Data Set: C:\Users\trevora\Documents\2021_Moves\11055\11055 Current.aqt

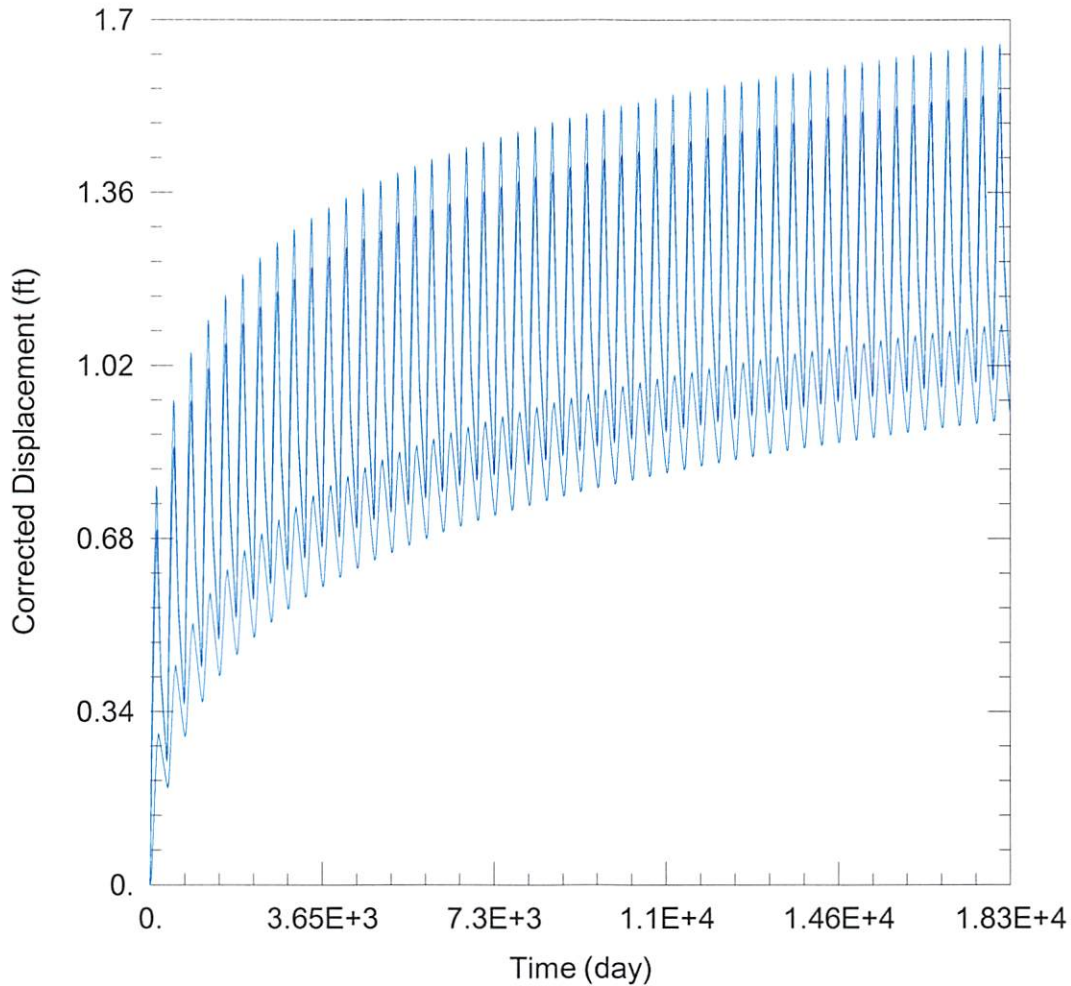
21549 ID2: Drawdown from current location = 1.55 ft
 Drawdown from proposed location = 2.61 ft
 Net drawdown = **1.1 ft**

Net drawdown does not exceed the drawdown allowance of 3.5 ft for any well within 1 mile of the proposed location. Therefore, critical well analysis is not necessary.

The proposed move is likely to create minimal effects on neighboring wells and is unlikely to cause impairment. GMD3 staff recommends approval of this proposal.
